STAFF REVIEW COMMITTEE
- AGENDA -
BRUNSWICK SCHOOL DEPARTMENT BUILDING
46 FEDERAL STREET, BRUNSWICK

1. **Case # 14-007 – Botany Place Subdivision Amendment:** The Committee will review and provide a recommendation to the Planning Board regarding a Subdivision Amendment application, pertaining to proposed revisions to the phasing (Phases 7-10), condominium layout, utility, stormwater, and recreational space plans. Assessor's Map U19, Lot 2, in the Residential 4 (R4) Meredith Dr. – West McKeen St. Zoning District.

Re: Minor Amendment Application
Botany Place – Phase 7
Tax Map U-19, Lot 2

Re: Stormwater Analysis Update
Botany Place – Phase 7
Brunswick, Maine

SITE PLAN - PHASE 7

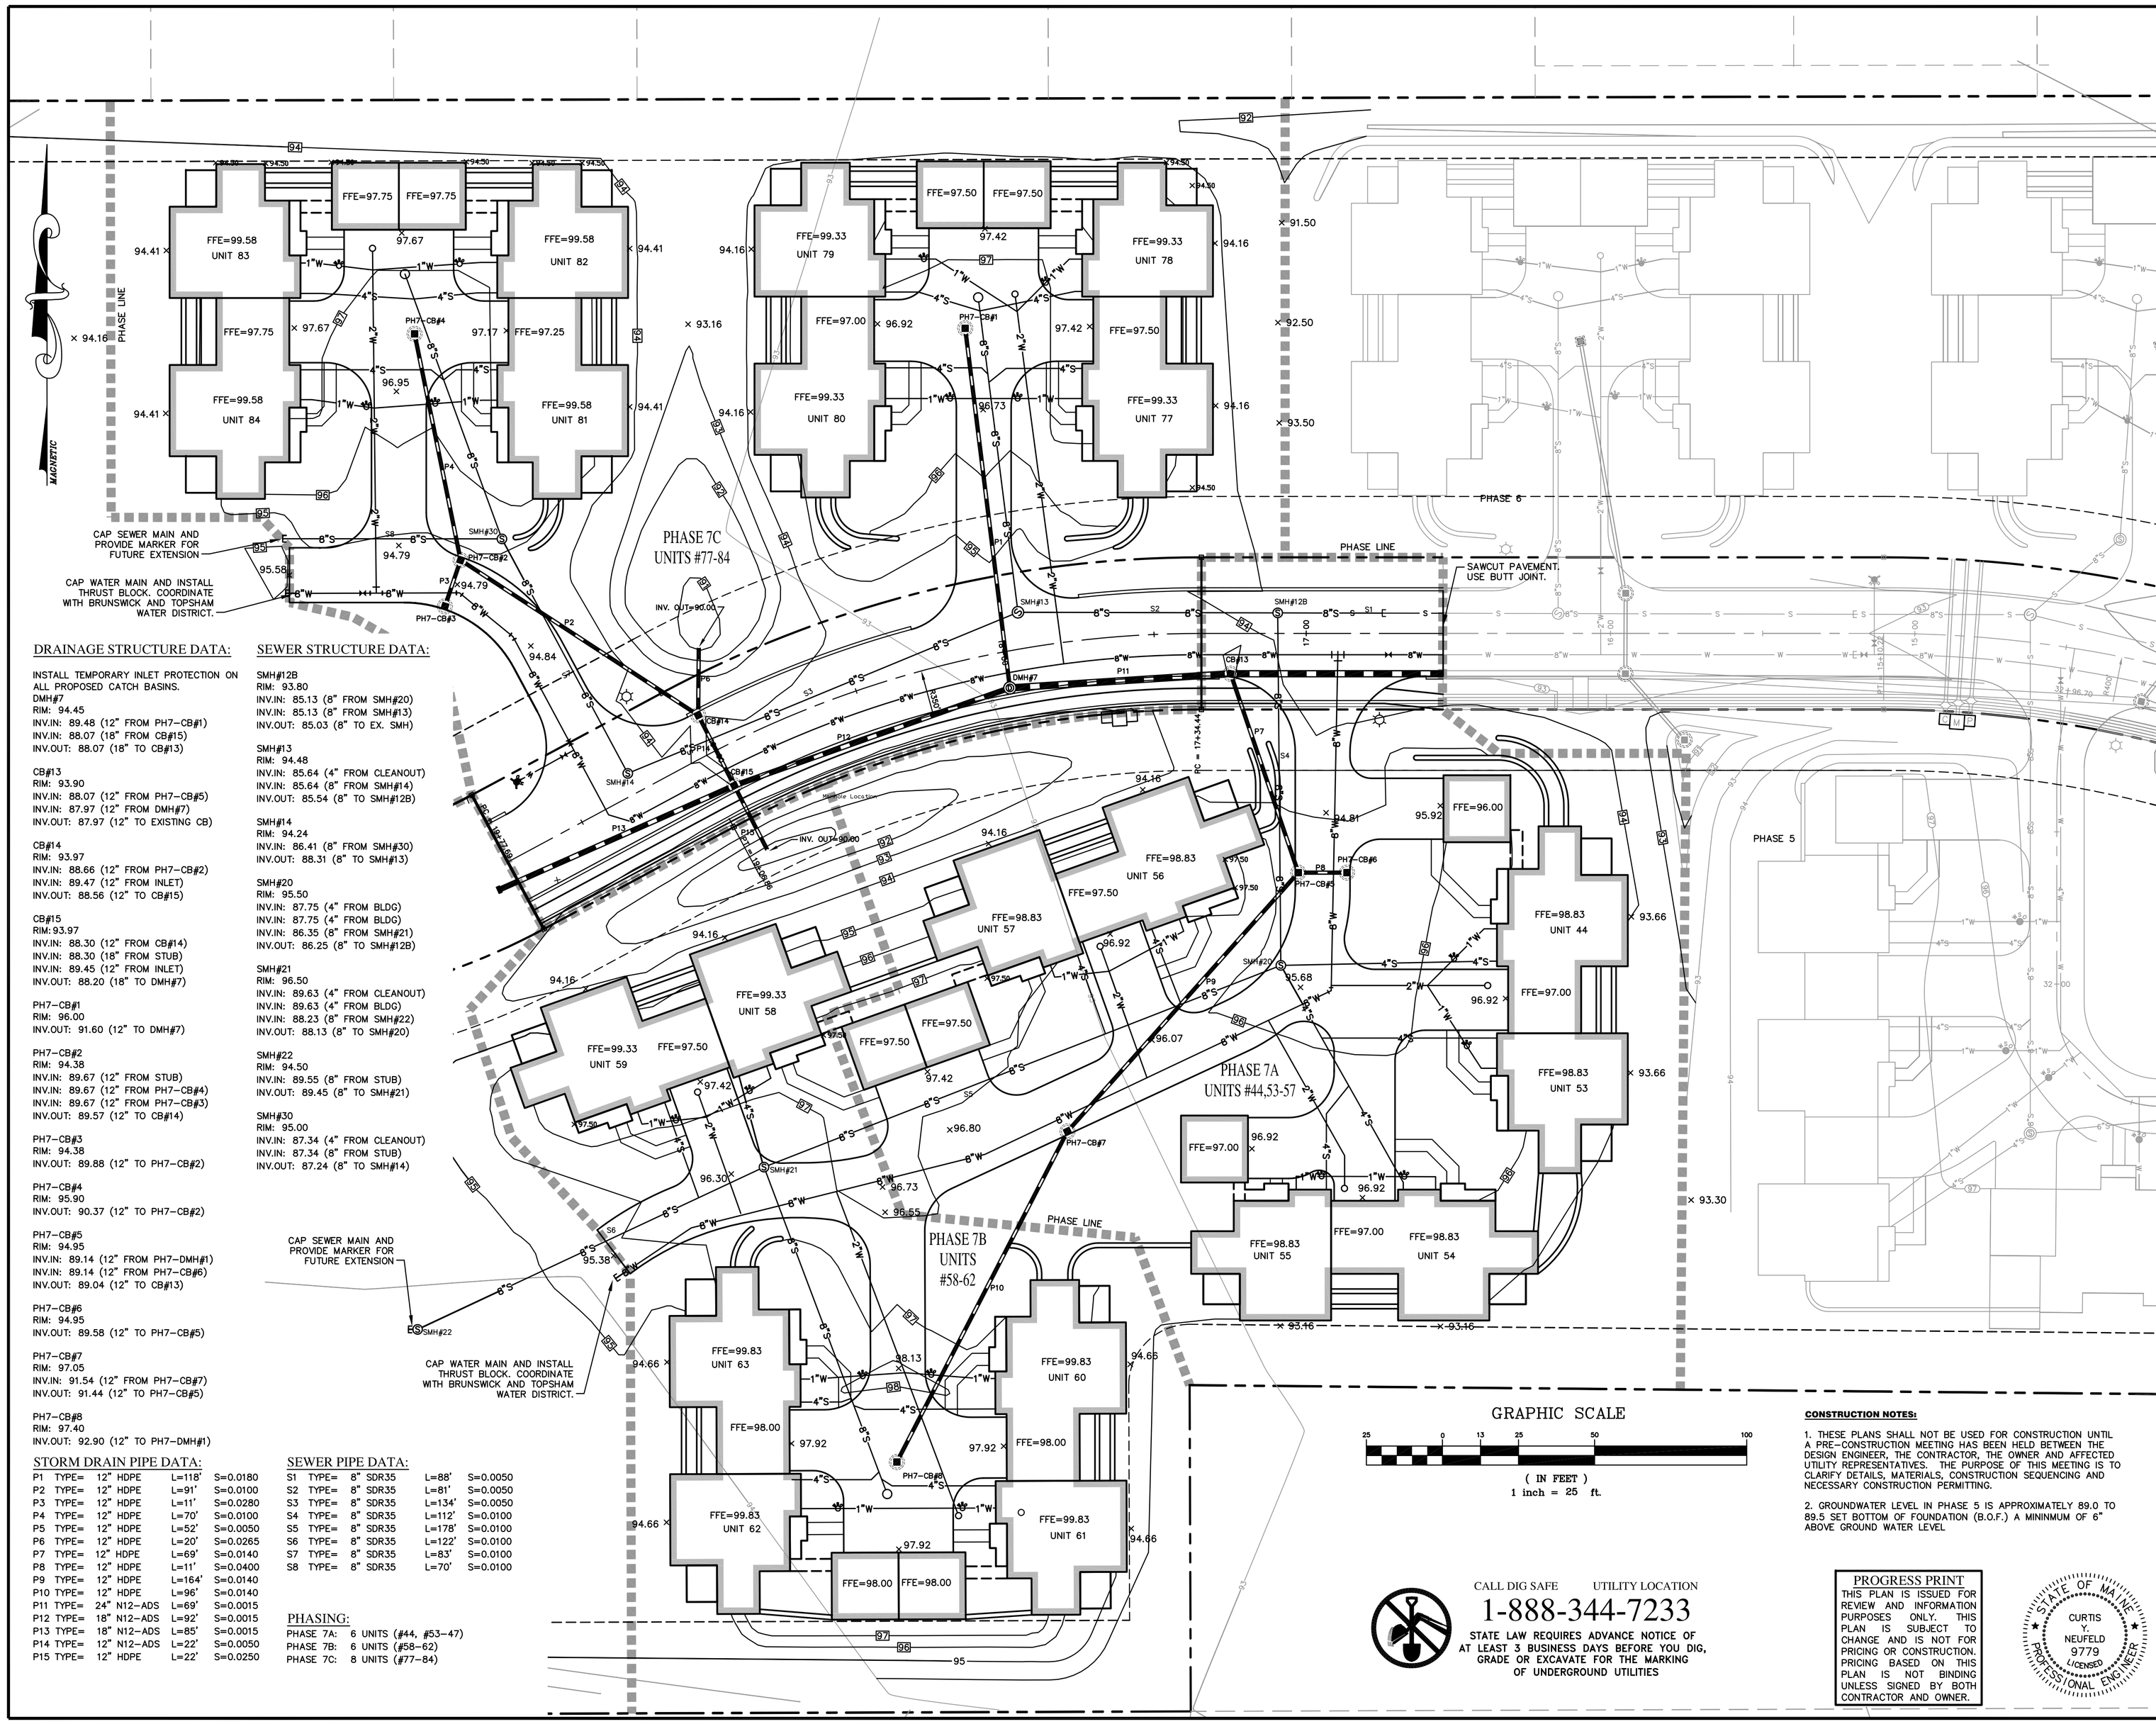
Enclosed please find ten (10) copies of the Minor Amendment Application Form, revised plans, and supporting documentation for revisions to Phase 7 of the Botany Place Condominiums. At this time, Botany Place, LLC proposes to revise the layout of the condominium units for Phase 7, including units 44, 53-63, 77-80, and 81-84 as identified on the Master Plan. As the proposed revisions to the enclosed plans reflect only revisions to the footprints and layouts of the units within Phase 7 and do not affect the overall density of the development, we respectfully request that a minor Amendment application be granted for the project.

In addition to the revisions to the buildings, utility and storm drain locations have been revised to better accommodate the new layout. We have coordinated with the Brunswick Sewer District and the Brunswick and Topsham Water District to ensure they are satisfied with the revisions to their respective systems. The new utility and storm drain layout is shown on the enclosed plans.

Attached please find a copy of an Amended Site Plan for Phase 7 of the Botany Place Condominiums. The amendment includes revisions to the building footprints and locations and corresponding adjustments to the grading and utility connections. The essential elements of the development remain unchanged, however. The units are arranged to face and be accessed from private loop roads served by Botany Place Drive. Stormwater runoff will be conveyed via swales to a storm drain system and ultimately to the wet pond designed to serve the overall development. The number of units remains essentially the same. The configuration of the storm drain system and the tributary areas is consistent, if slightly modified, to the original design.
